Rezoning Transportation Analysis
Petition Number: Insert Zoning Petition #2021-201
General Location Identifier: Tax ID 12709305

Date	Description
12-23-21	First Review (WB)
02-21-21	Second Review (WB)

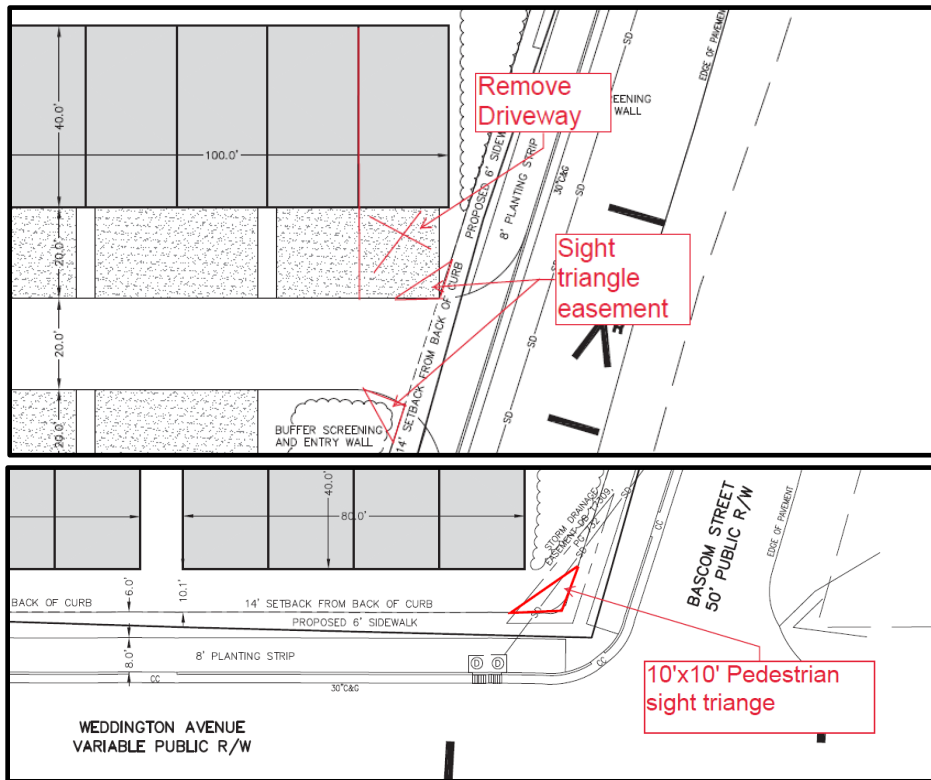
- Comment Clarification (Unaddressed Comment):** Revise site plan and conditional notes to commit to dedicate a 36-foot right-of-way from the road centerline on Weddington Avenue and Bascom Street. The site plan shall label and dimension the right-of-way from the road centerline.

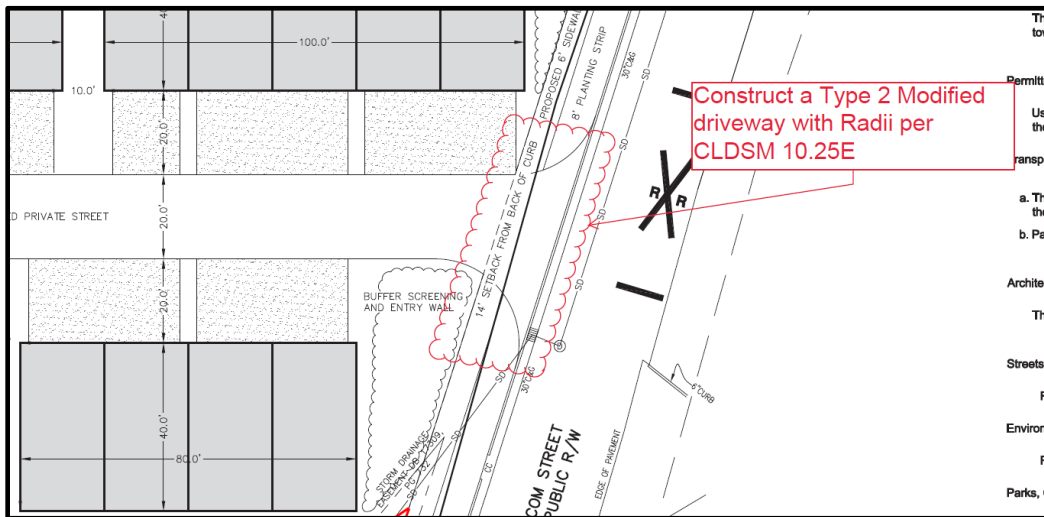
- ~~Site plan and conditional notes revisions are needed to provide 10' x 10' pedestrian sight distance easements for any portion of the pedestrian sight triangles located outside the right of way and within the development. Remove proposed driveway from the pedestrian sight triangle. The pedestrian triangle measures 10 feet x 10 feet with one leg measured along the back of sidewalk or right of way (whichever is the greater distance from the curb line) and the other leg measured along the driveway face of curb or edge of pavement. Also provide Pedestrian sight triangles at the intersection of Weddington avenue and Bascom Street.~~

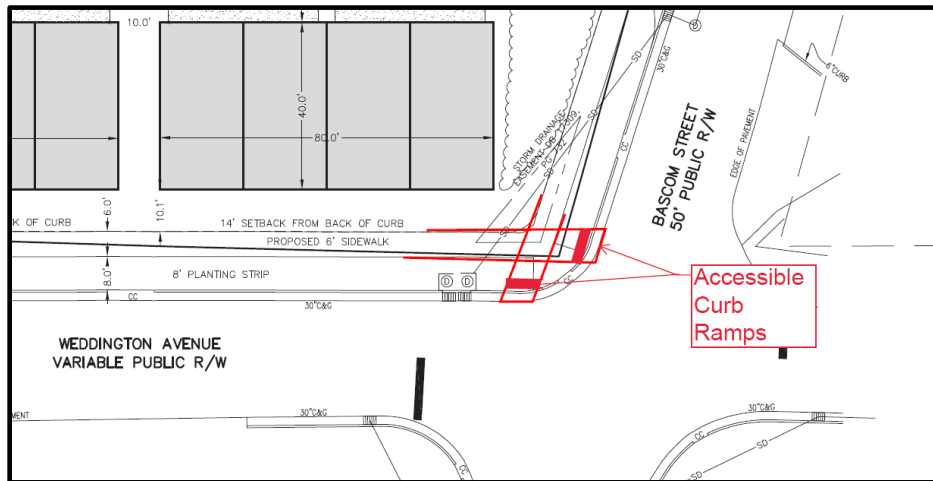
6. ~~Site plan revisions are needed to construct a CDOT standard driveway per CLDSM 10.25E. Proposed radii must match the City standards.~~

7. ~~Revise Site plan to construct two (2) accessible curb ramps at the intersection per PROWAG and ADA law.~~
